Building Surveyor's Report

AMMENDED PLAN OF BUILDING ON PLOT

Nº 28A SHEET Nº K-4

LYAREE Q5

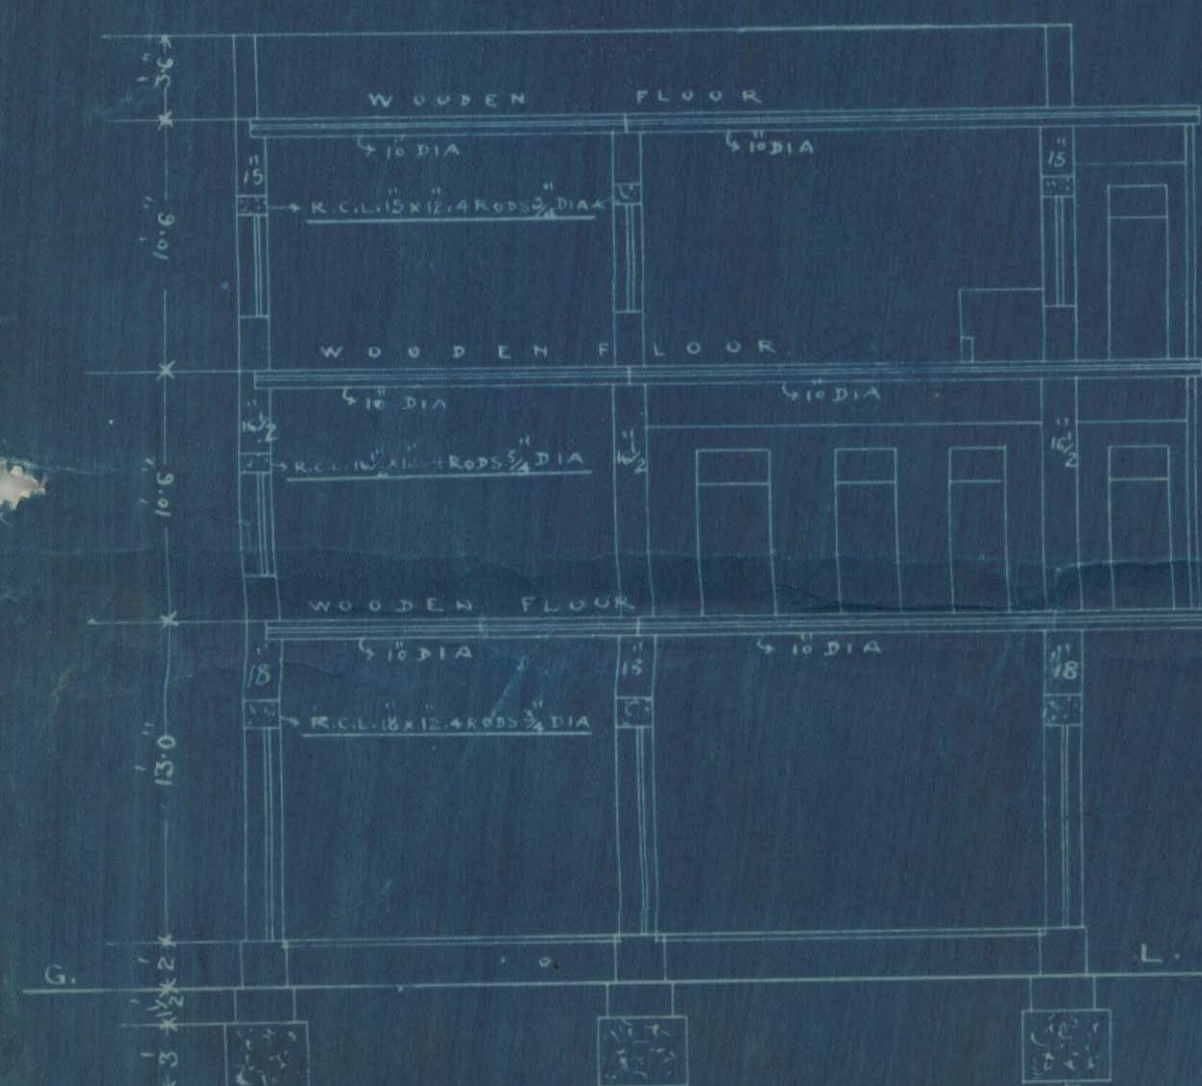
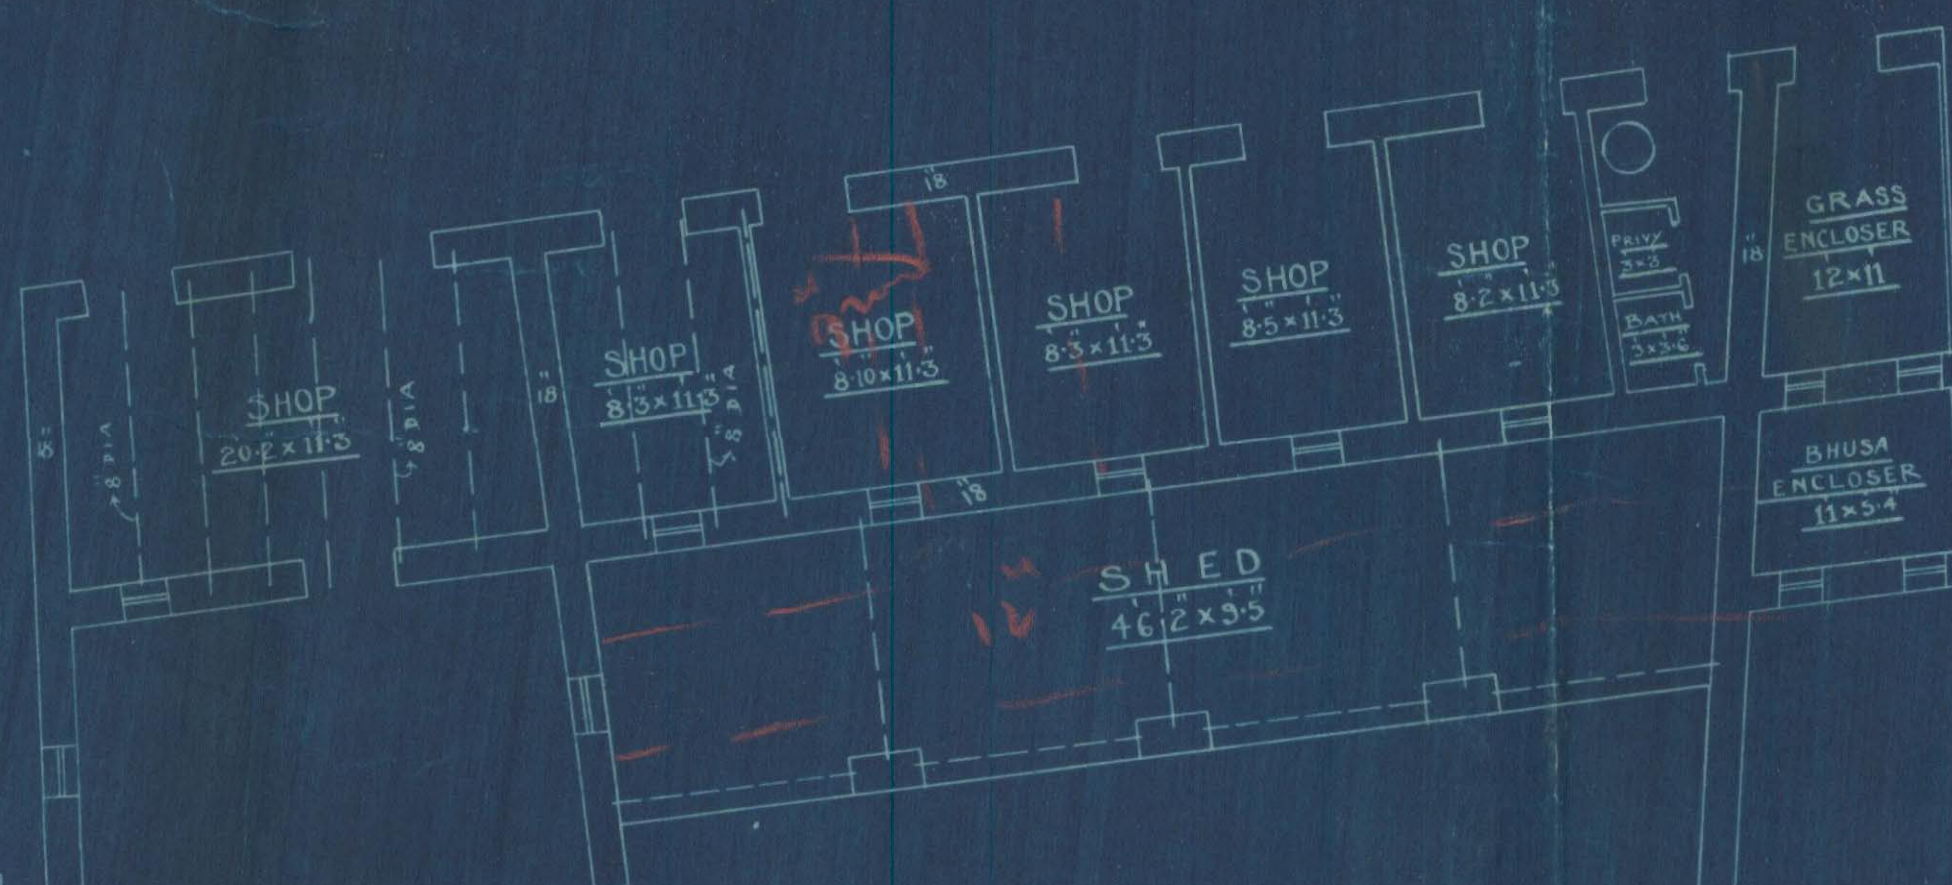
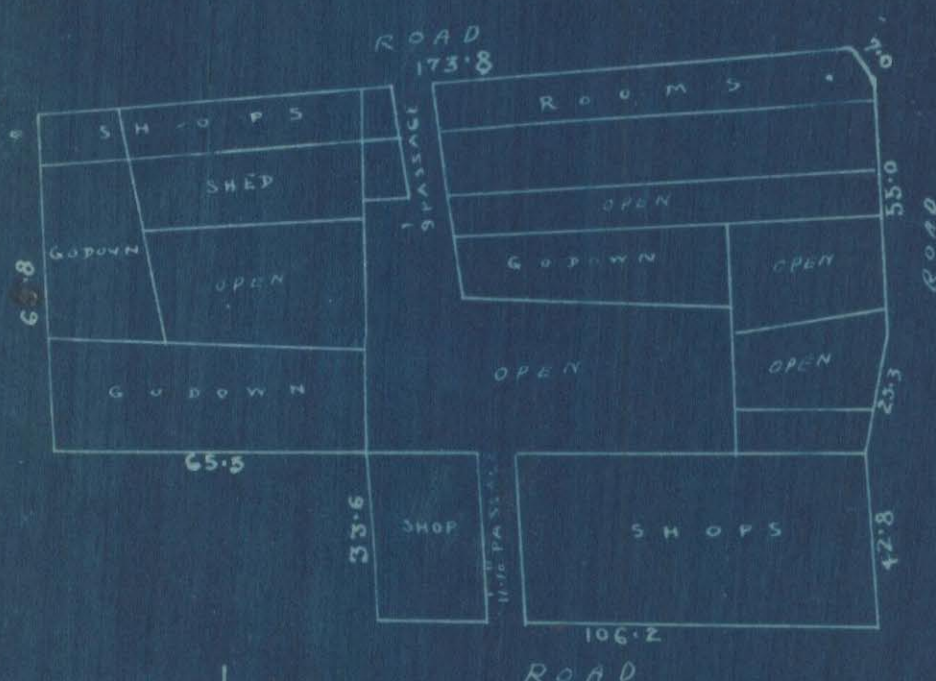
(1) The owner must sign all the plans.

(2) Plans must be fully dimensioned. ~~At to~~

(3) All the beam arrangement with their dimensions must be given.

(4) Nature of all partition walls must be given.

(5) Details of the trusses must be given with their dimensions.

(6) The architect is requested to come and correct the plans.

(7) WC shown in plan near the passage at the west is wrong on site and WC at the northern block is bath on site which must be corrected. Drainage arrangement must be shown on plan.

The plans have been
corrected by the Architect
& the same may now be
approved

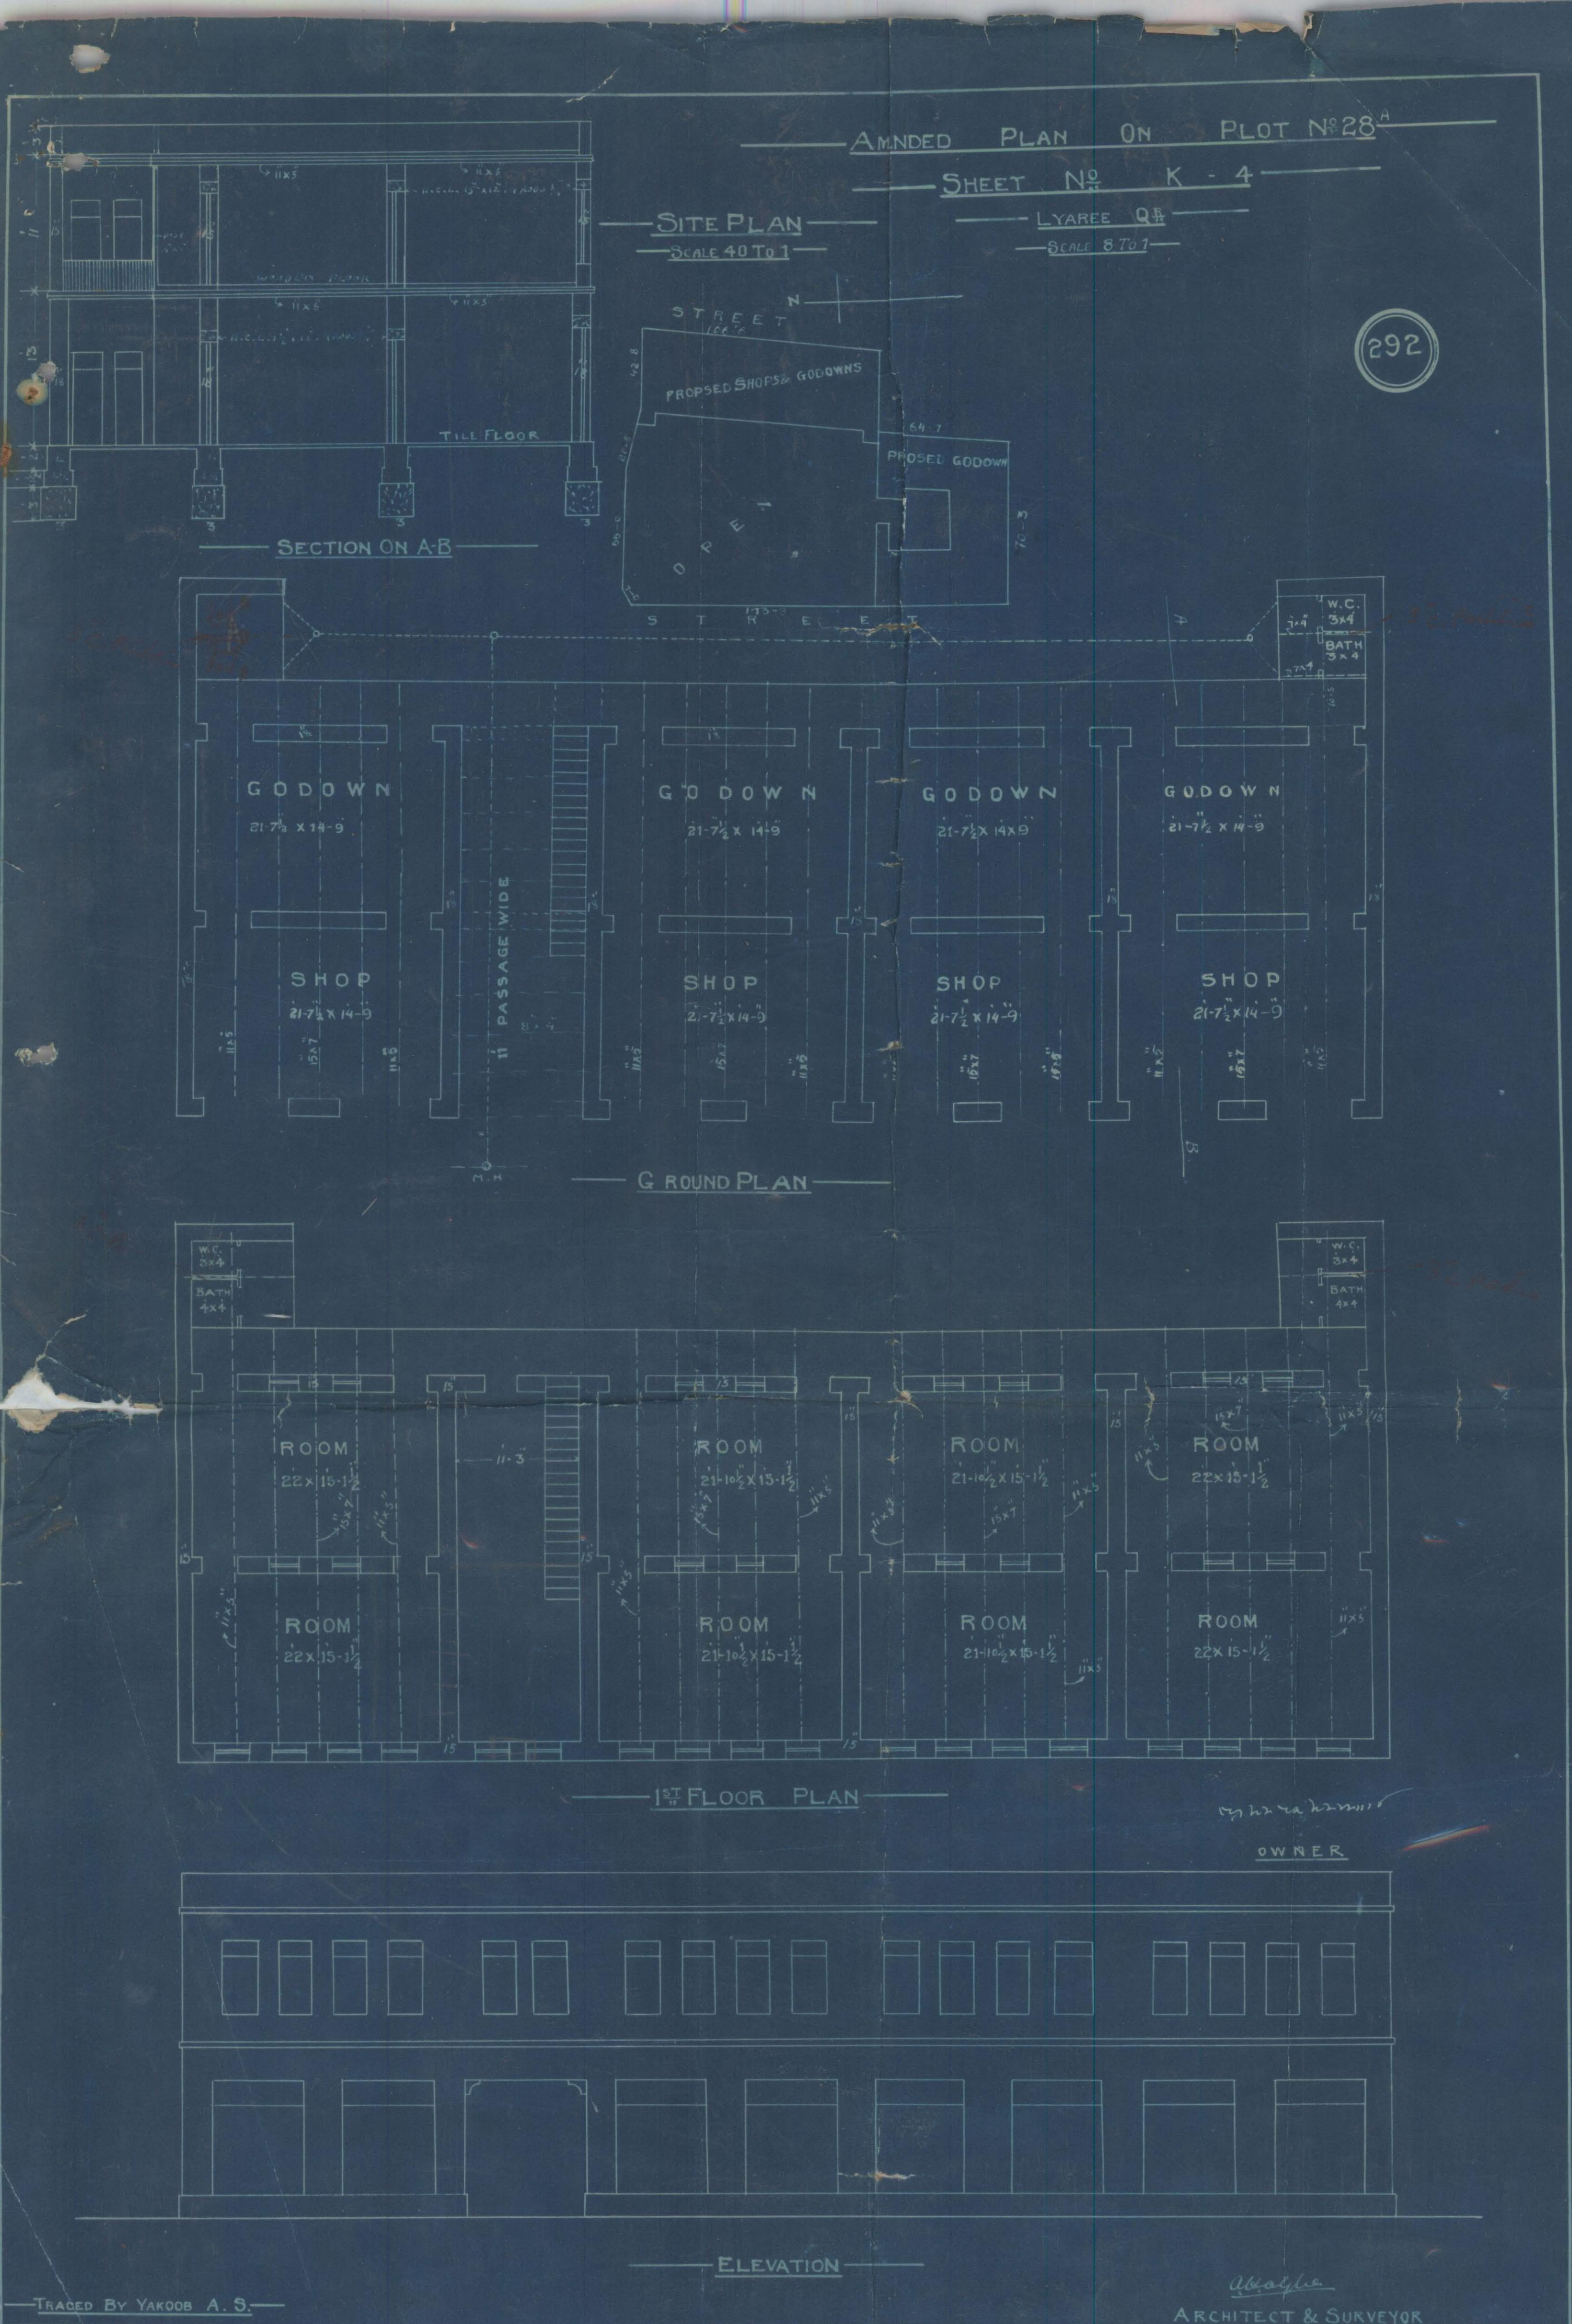
- ✓ (1) The owner must sign the plans.
- ✓ (2) Area marked 'A' must be named for the purpose it will be utilised.
- ✓ (3) Nature of the walls of the sanitary block must be mentioned on plan.
- (4)
- (5)
- (6)
- (7)
- (8)
- (9)

(1) The owner must sign the plans.(2) Area marked 'A' must be named for the purpose it will be utilized.(3) Nature of the walls of the 'Sanitary' block must be mentioned on plan.(4) Size of the beams must be 12" x 6" and not 11" x 5" as proposed.

1. The plan is already signed & the
owner please the plan.
2. The area Marked A is covered
for the purpose of 1st floor building.
3. The nature of similar block is 3"
Cement. p. wall.
